Business Unit: Electronics **PCN/21/019/C+N-US**
Product Range: Network Interface Connectors / M23 **Date:** 05/03/2023
Title: **Design change of M23 angled housings - External** Page 1/1

Details of the Product Changes

M23 Signal:

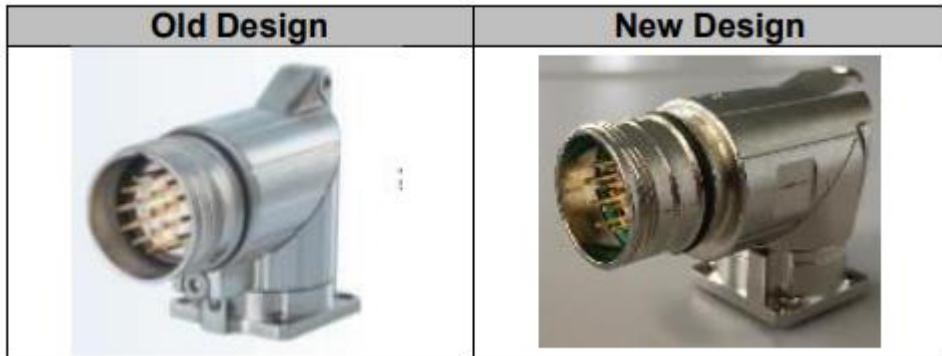
1. Concerned Part Numbers
09151000902 09156000902 09156000912
2. Description of Changes/News
<p>We need to inform you that contrary to what was written in the PCN of May 2021 we have to consider some restrictions on the use of the new enclosures! → For details please look at: “3. Impact on product specification”</p> <p>We informed you about the change of angled rotatable housings of our M23 circular connector Portfolio. Instead of the hinge that connected the upper part of the housing with the flange, these two parts are now separated and can be fixed from above the connector with a screw.</p> <p>This change is a combination of a design and feature adjustment. Besides the optimization from design point of view, it has also positive effects on the assembly process and a higher robustness.</p> <p>This change is concerning the rotatable device housings with flange from M23 Signal and M23 Power/Hybrid Portfolio.</p>

The new enclosures can not be used with female inserts.
